## STRUCTURAL ASSESSMENT – Delco Activity Center (BLDG-284A)

## Delco Activity Center – Summary of Structural Repair Recommendations

Vertical Cover Plate Concealing Opened CMU Control Joint at NW Entry

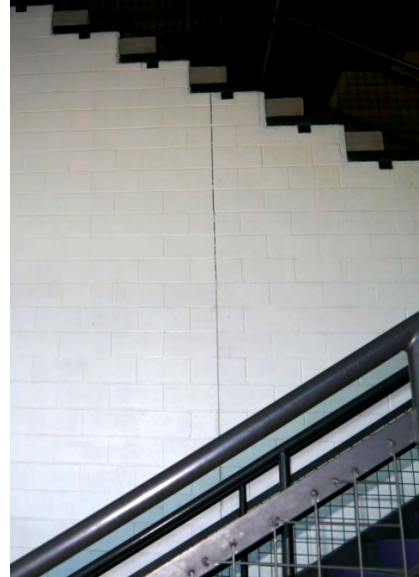
- **CMU at Corner Entries:** Long, tall CMU walls are exposed at the ends of the bleacher seating adjacent to the entry stairs at each corner of the building. Vertical control joints in the exposed CMU walls at the NW and SW entryways had visibly opened (widened) near the top of wall. The joints appeared normal (typical width) lower on the walls (closer to slabs). The vertical control joints in the same CMU walls at the NE and SE entryways appeared normal width for the full height of the walls.

**4. Cracked CMU Walls:** Seal larger cracks with a flexible sealant. Existing control joints that have opened can be cleaned and resealed with a flexible sealant.

Separation at Top of Abutting Interior Walls

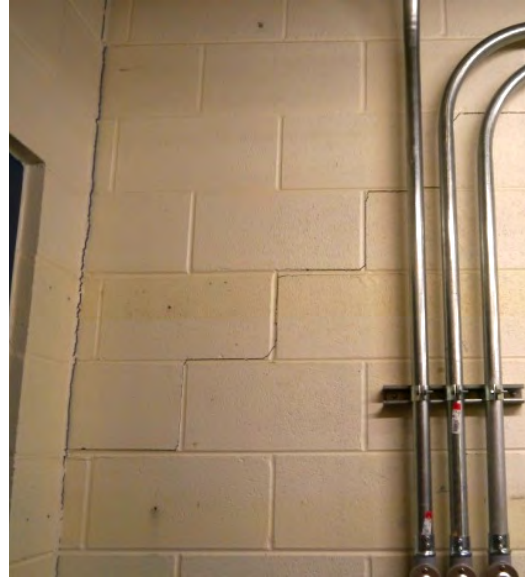
- **CMU at Outer Walkways:** Long CMU perimeter walls at the inside faces of the pre-engineered building superstructure were exposed along the long walkways on each side of the building. No cracks were observed in these walls because the CMU walls had recently been repainted and any small cracks would likely have been concealed behind the new paint coat. Large cracks, however, would have likely reflected through the new paint but none were detected.
- **Interior Walls:** Large cracks were observed at several of the building's interior walls.

Abutting Interior Walls Have Separated, Diagonal Cracks in Interior CMU Wall

We suggest treating CMU wall cracks and where abutting walls are separating in a similar manner – fill with a flexible sealant.

Large Slab Cracks at Corner Entryways

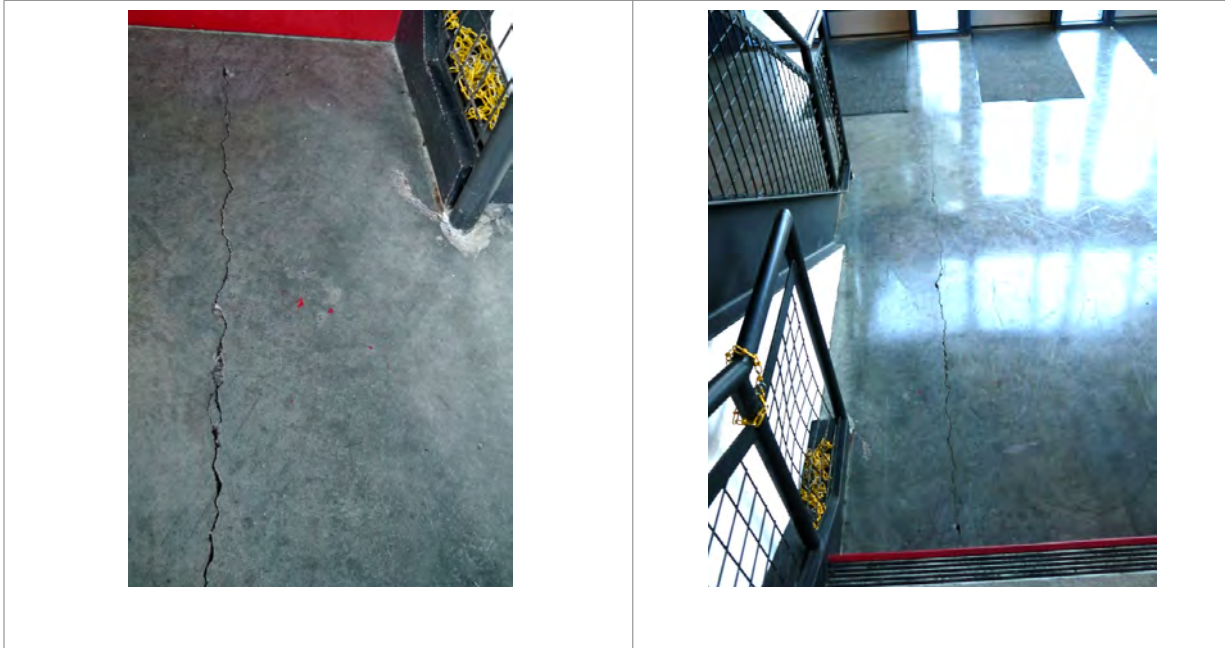
- **Slabs at Corner Entryways:** Large cracks were observed in the exposed concrete slabs at the corner entryways. The cracks typically ran from the perimeter of the building to the stairs leading up to bleacher seating.

Large Slab Cracks at Corner Entryways

**3. Cracked Topping Slab:** Rout and seal larger cracks and cracks exposed to foot traffic with a flexible sealant.

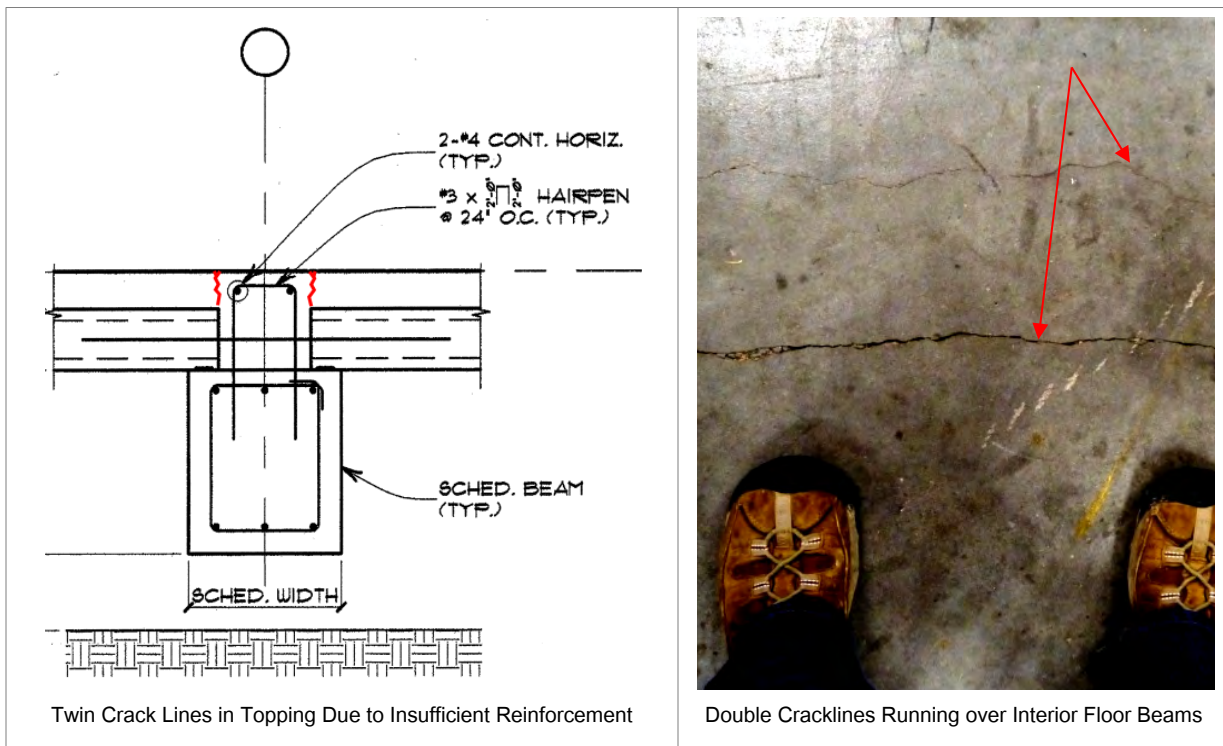
- Slab Twin Crack Lines:** Small- to large-sized twin crack lines were observed in the topping slab throughout the facility; the double crack lines run parallel to each other roughly 12" apart. The observed crack lines generally ran in the north-south direction and seemed to coincide with beam lines. Similar cracks ran north-south adjacent to existing double control joint lines (also over beams). These cracks are likely reflective cracks occurring over the hollow-core plank ends bearing on the floor beams, and this type of cracking is relatively common in topping slabs with insufficient reinforcing to support the tension forces in the top of slab either because enough steel area wasn't provided or the slab reinforcement was not chaired properly during construction. See detail below – the red line represent the twin crack lines.

The slab cracks should be treated otherwise they are likely to worsen over time. We suggest routing the larger cracks in walkways and public-use areas and sealing with a flexible sealant that will accommodate future movement. The double crack lines over ends of hollow-core planks can be left alone if small, or if cracks are large or if foot traffic causes the cracks the worsen over time then they can be treated in a similar fashion to the entryway cracks (rout and seal).

Large Slab Cracks Adjacent to Double Control Joints

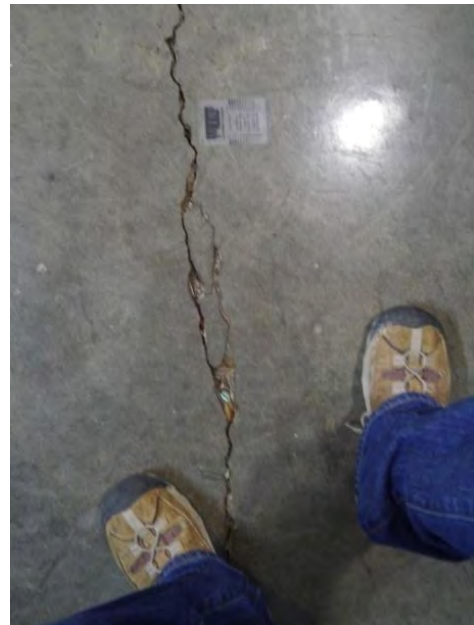
Large Slab Cracks Adjacent to Double Control Joints

Finish Damage at Top of Red Column Near NW Entryway

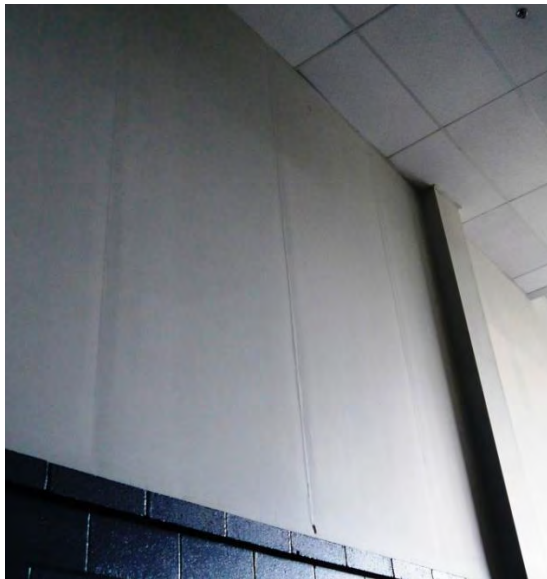
- **Cosmetic Damage to Interior Finishes:** Small cracks in wall finishes were observed around the facility.

**5. Interior Finishes:** Damage to interior finishes was minimal but can be repaired if desired. Any repairs to finishes are purely cosmetic and are not required structurally. Also, please note that differential soil movements may cause finishes to crack and separate in the future, so it may be worthwhile to monitor finishes after other repairs are made to verify damage will not recur before repairing.
